APPLICATION NUMBER: MM 25-1375

ZHM HEARING DATE: December 15, 2025

## AGENCY REVIEW COMMENT SHEET

The applicant is requesting a Major Modification (MM) to a +/- 3.07 ac. portion of a +/- 106.52 acre project previously zoned Planned Development (PD) 15-0694, and as most recently modified via MM 22-0416. The project is currently approved for a variety of uses, including 424 single-family detached dwelling units within Pod B, and up to 50,000 s.f. of certain uses within Pod A, including all Business Professional Office (BPO) uses as well as eating establishments (without-drive throughs), home furnishing stores, hobby shops, florists, consignment stores, paint stores, newsstands, gift shops, jewelry stores, pharmacies, antique stores, bank/credit unions, personal service uses, a dog kennel, a (1 bay) car wash and motor vehicle repair (neighborhood serving) uses.

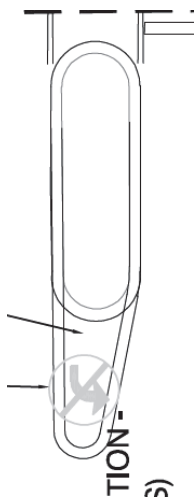
- On Sheet 2 of 2, restore the “no left turn arrow” symbology to the site as is shown below and that is shown on the existing approved plan (which staff notes clarifies which left turn is being restricted).
